DESIGN ADVISORY BOARD Tuesday, January 27, 2015 at 3:00 PM Conference Room 12, City Hall, Burlington, VT

TO: Design Advisory Board
FROM: Scott Gustin
DATE: January 27, 2015
RE: 14-0734CA/CU, 502 North Street

Request: Rear addition to home, driveway expansion, and creation of accessory apartment.

DODSON RESIDENCE
502 NORTH STREET
DESIGN ADVISORY BOARD SUBMISSION
JANUARY 14, 2015

4 NORTH ELEVATION
SCALE: 3/16"=1'-0"

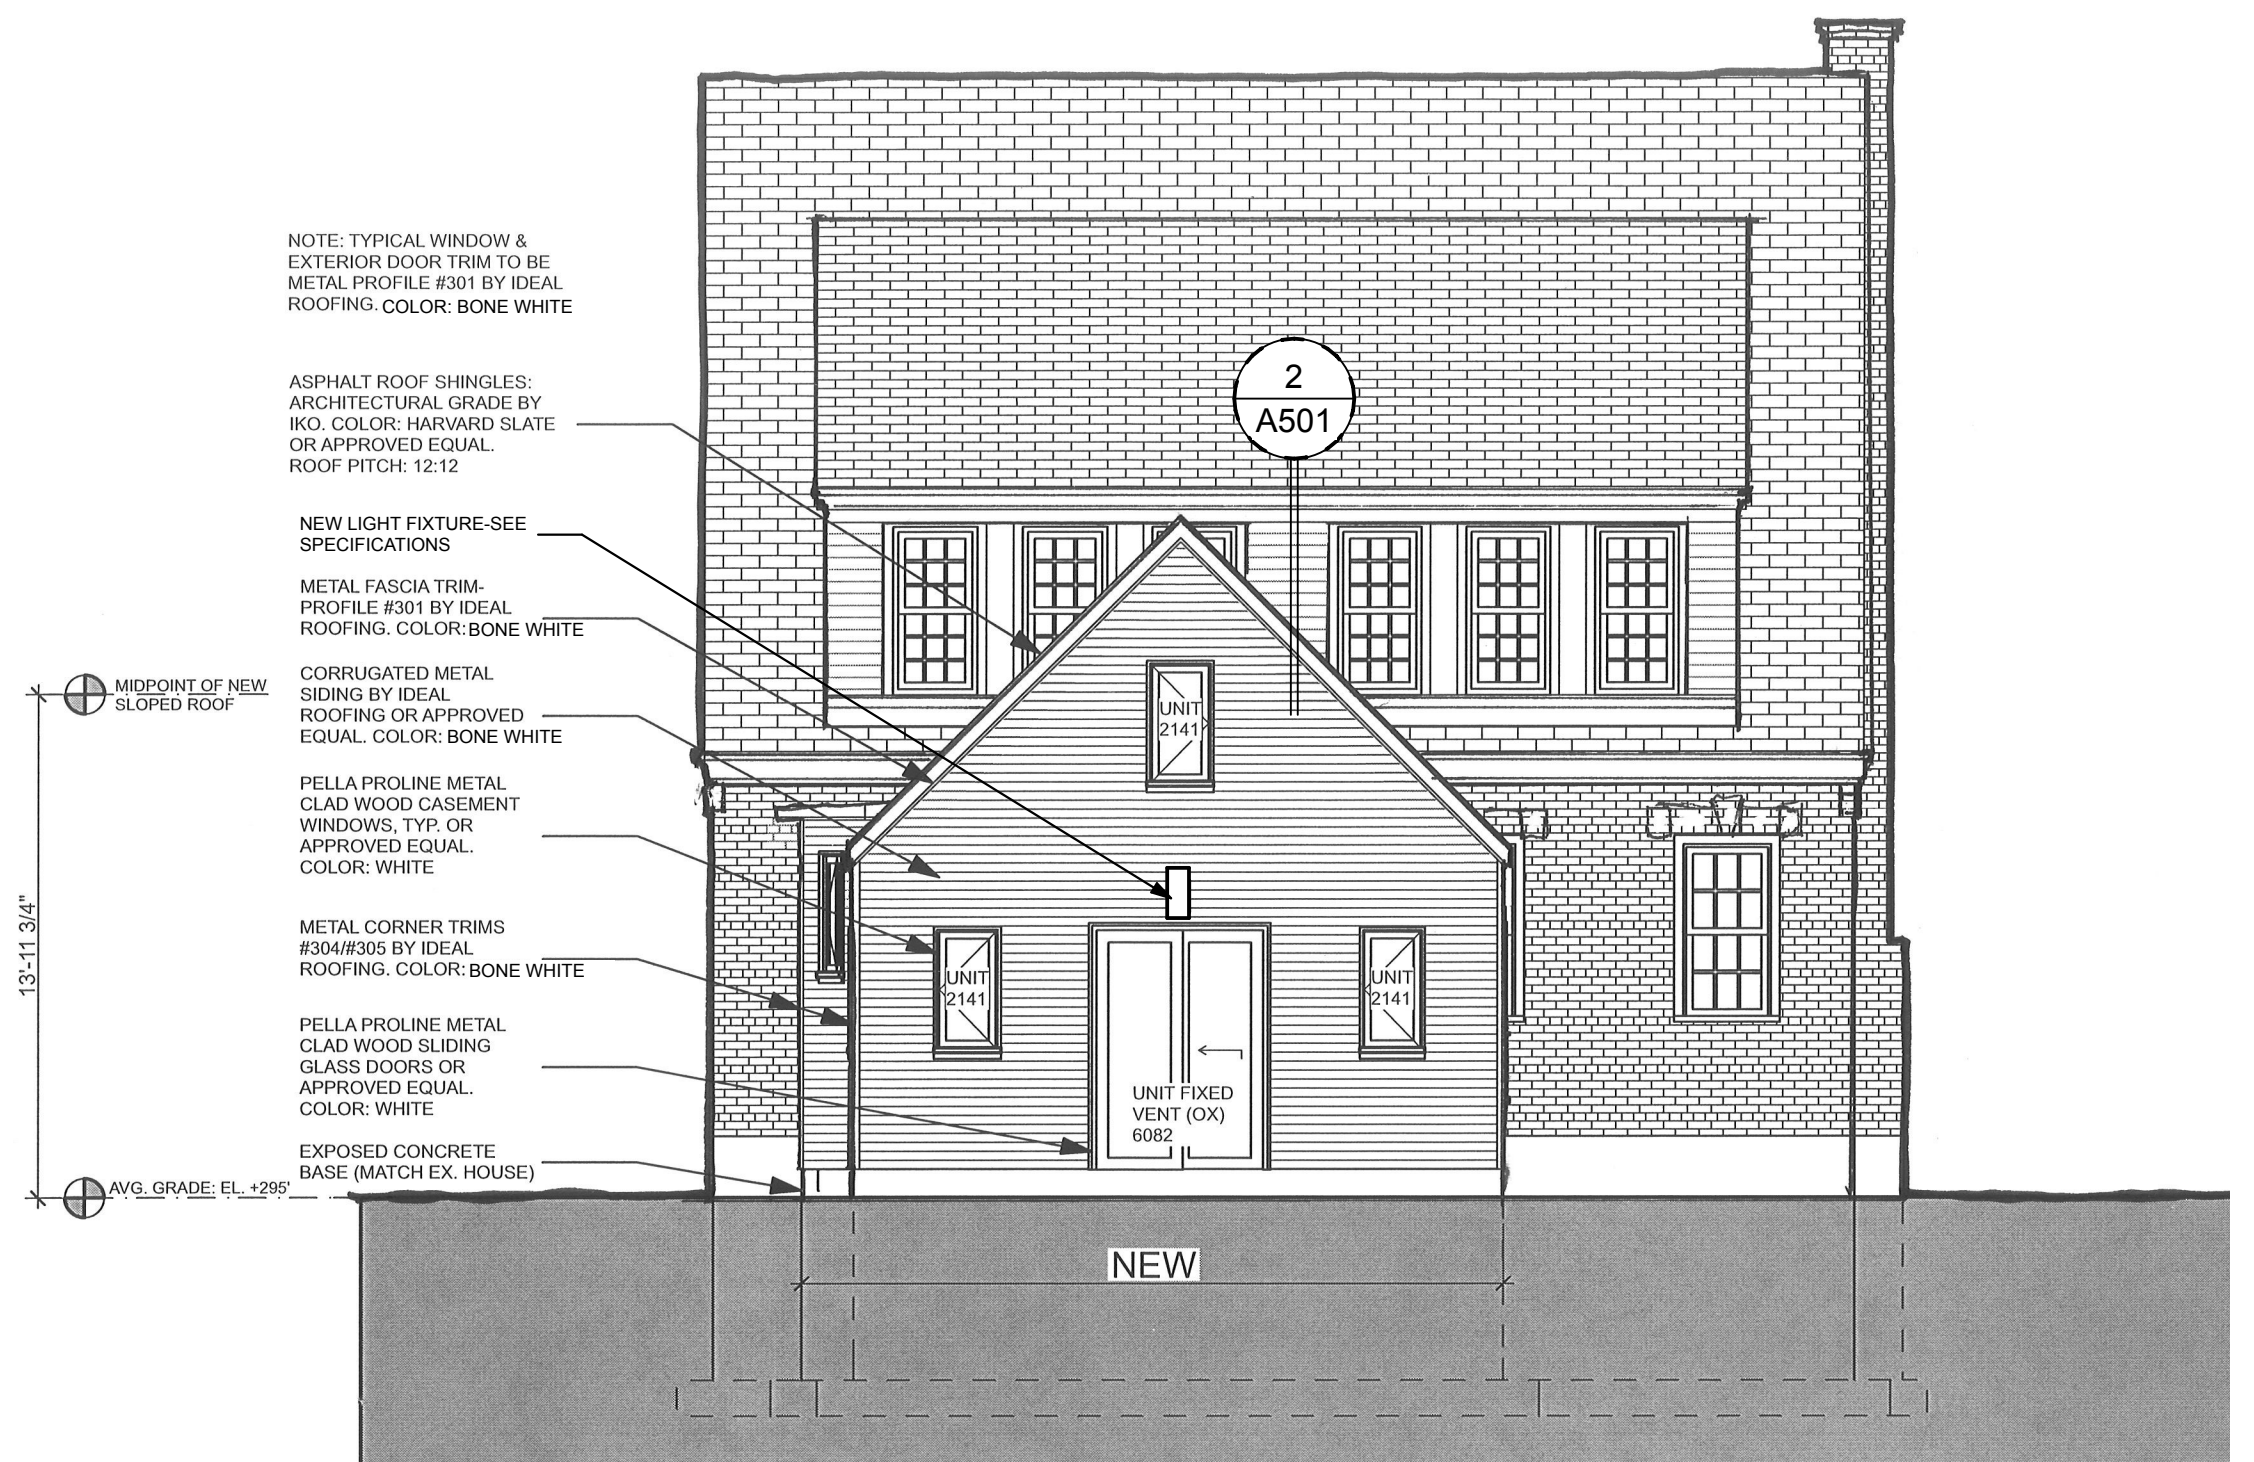
No outdoor lighting information has been provided and must be. Presumably, at least the new doorways in the proposed addition and apartment will be illuminated. Fixture cut sheets and locations need to be specified.

No changes are proposed to the front entry of the historic home. As for the addition, the mudroom will have a doorway facing the driveway, and the apartment will have an entrance facing the back yard. This rear-facing orientation is acceptable as a rear addition. Single-lite casement windows are proposed in the mudroom and apartment, and full-lite exterior doors will be installed. The mudroom and apartment addition may, and should, clearly differ from the original home. Both do so; however, the windows are an opportunity to provide some tie-in between the original and new construction. As proposed, there is no relationship between windows in the original home and the new construction. Proportions of windows, whether ganged or single, should mimic those in the existing home. Likewise, windows in the new

construction should match the style of those in the existing home (i.e. simulated double hung units of either six-over-six or two-over-two appearance). Muntins and the dividing bar should be factory-adhered to the exterior of the new casement units.

New light fixtures will be provided to illuminate both the entrance door at the proposed Mudroom and also the sliding doors on the north side of the new apartment. The exterior elevations have been revised to show proposed fixture locations. Fixture cut sheets have also been provided as part of this addendum.
